DEVIATION REQUEST AND DECISION FORM

Project Name : CLOVERLEAF SUBDIVISION
 Schedule No.(s) : 7124202236, 7124202237, 7123102041, 7123102044
 Legal Description : SEE ATTACHED – Exhibit C

WHITE CLOVER DRIVE AND LEGGINS WAY INTERSECTION SIGHT DISTANCE

WHITE CLOVER DRIVE AND
 LEGGINS WAY INTERSECTION
 SIGHT DISTANCE
 CLOVERLEAF
 JOB NO. 2000-5158.01
 11/06/2020
 SHEET 1 OF 1

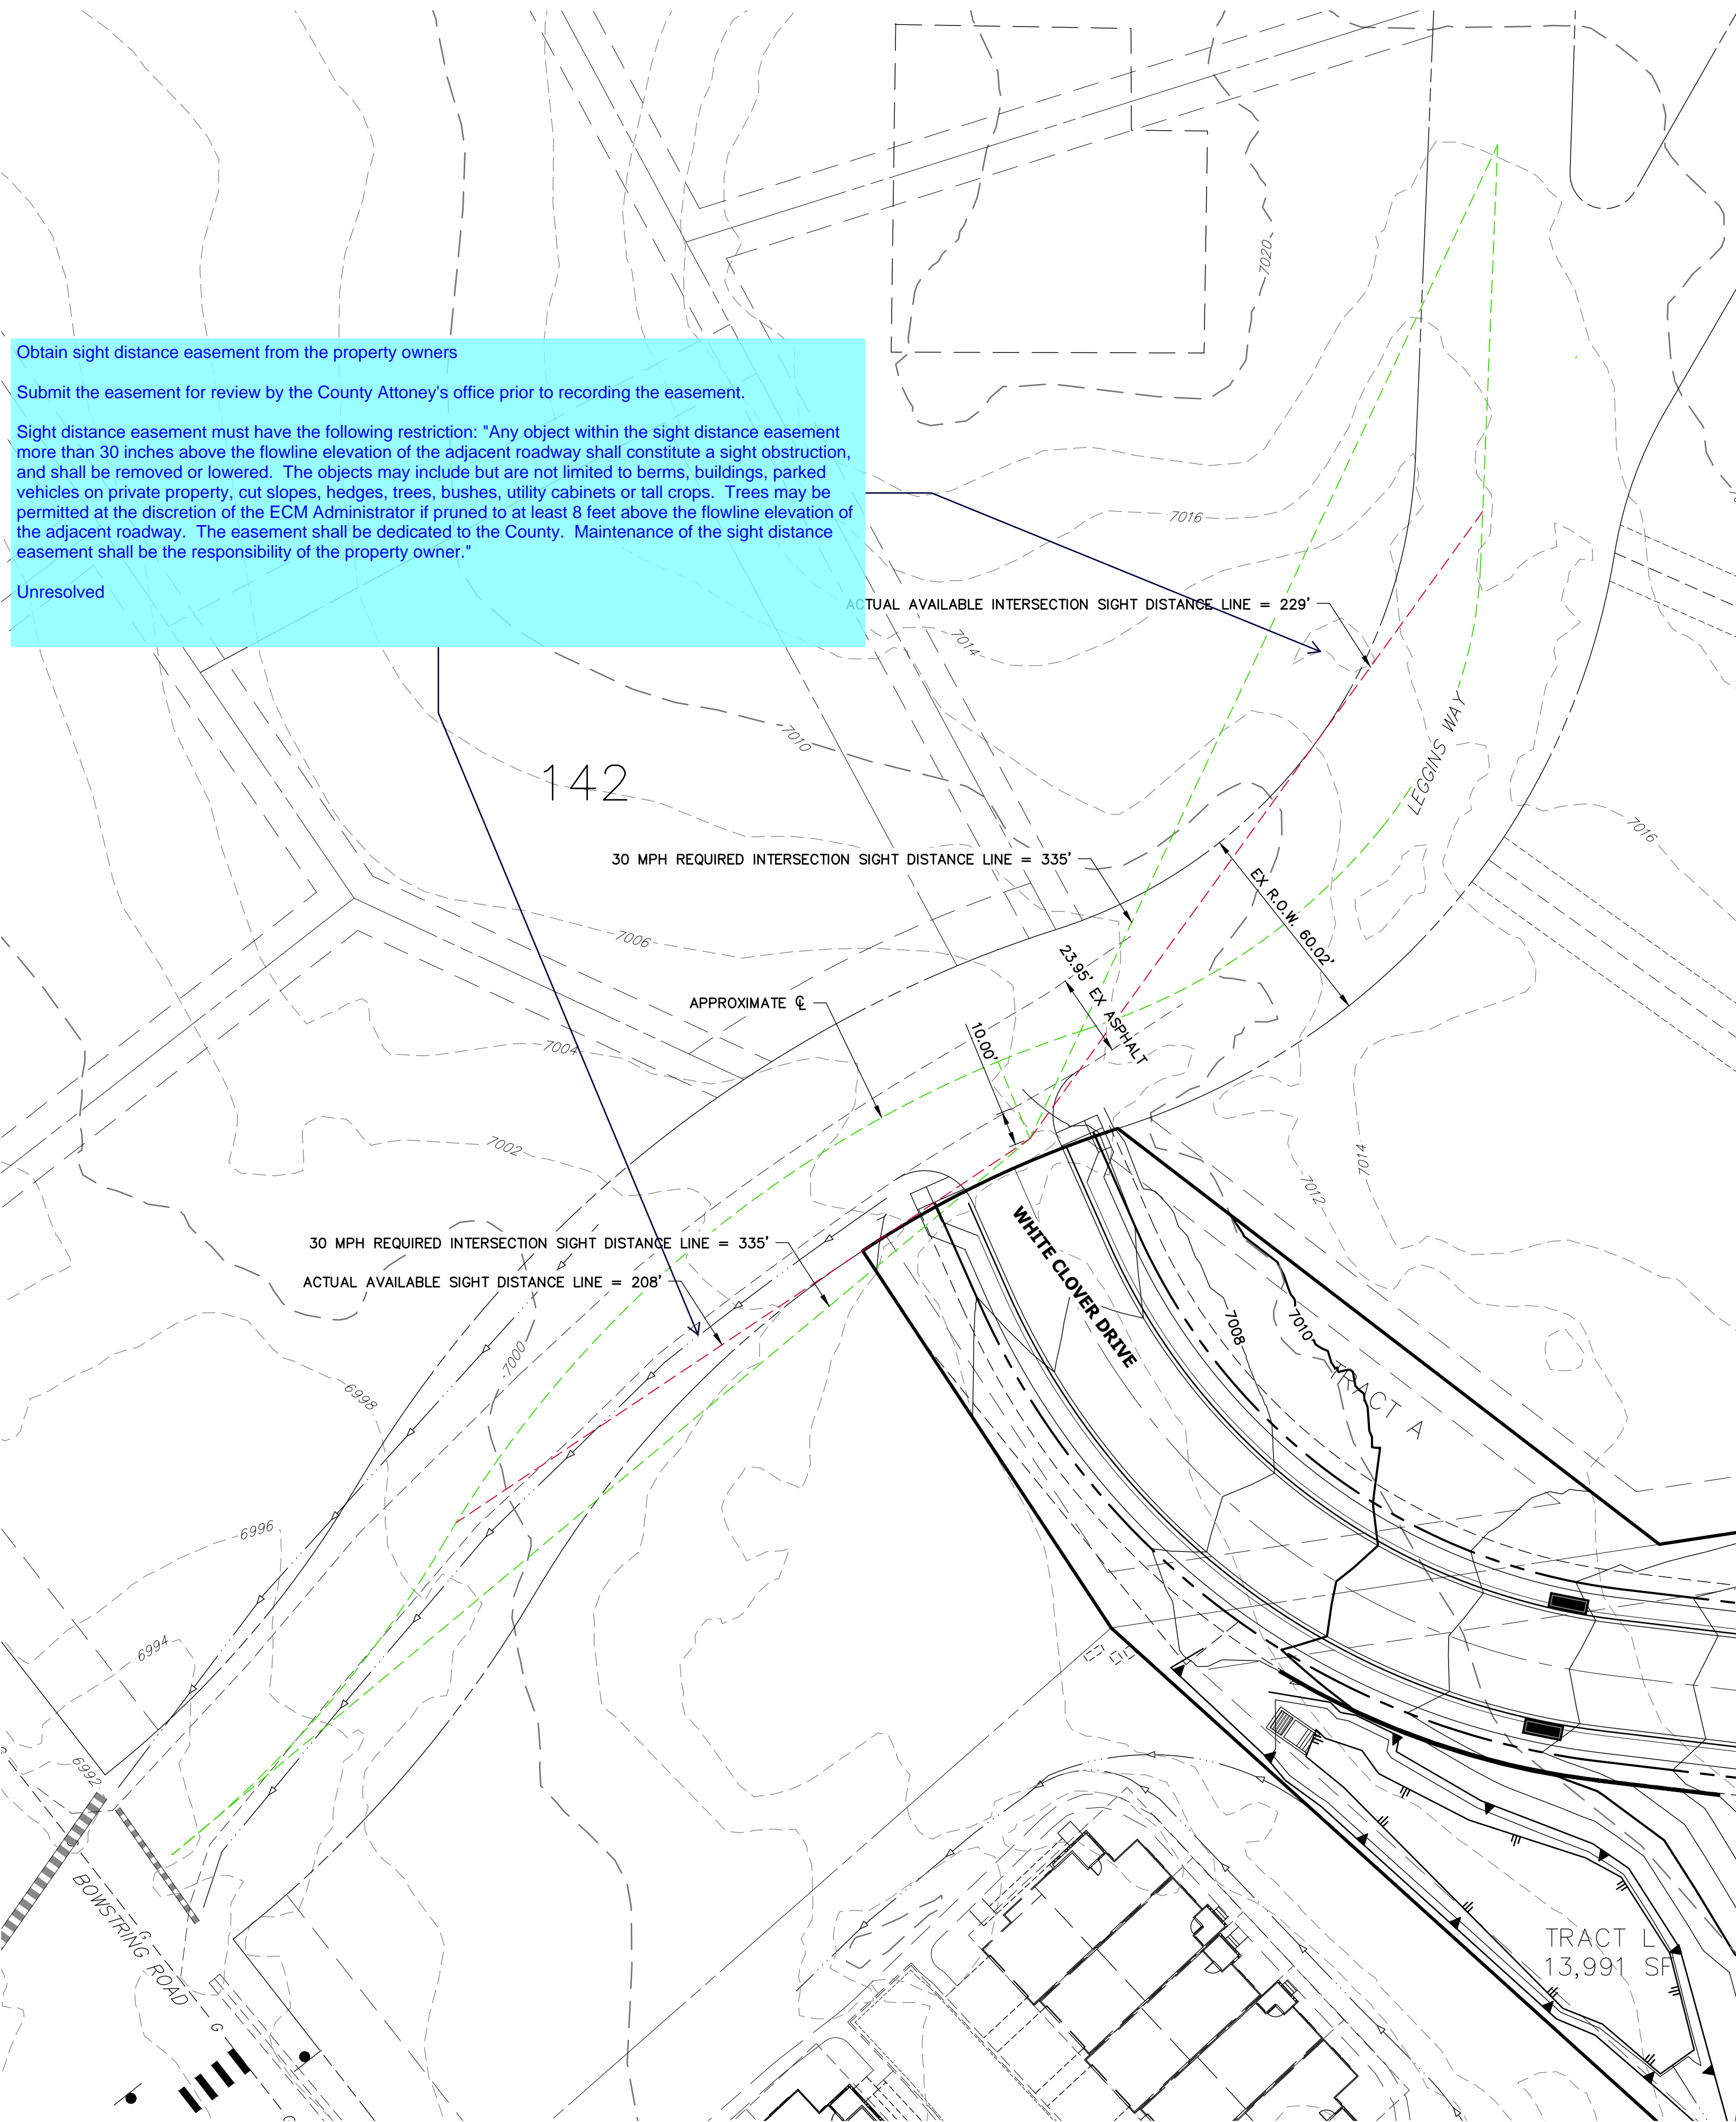
Obtain sight distance easement from the property owners
 Submit the easement for review by the County Attorney's office prior to recording the easement.
 Sight distance easement must have the following restriction: "Any object within the sight distance easement more than 30 inches above the flowline elevation of the adjacent roadway shall constitute a sight obstruction, and shall be removed or lowered. The objects may include but are not limited to berms, buildings, parked vehicles on private property, cut slopes, hedges, trees, bushes, utility cabinets or tall crops. Trees may be permitted at the discretion of the ECM Administrator if pruned to at least 8 feet above the flowline elevation of the adjacent roadway. The easement shall be dedicated to the County. Maintenance of the sight distance easement shall be the responsibility of the property owner."
 Unresolved

Show the proposed signage type and location.
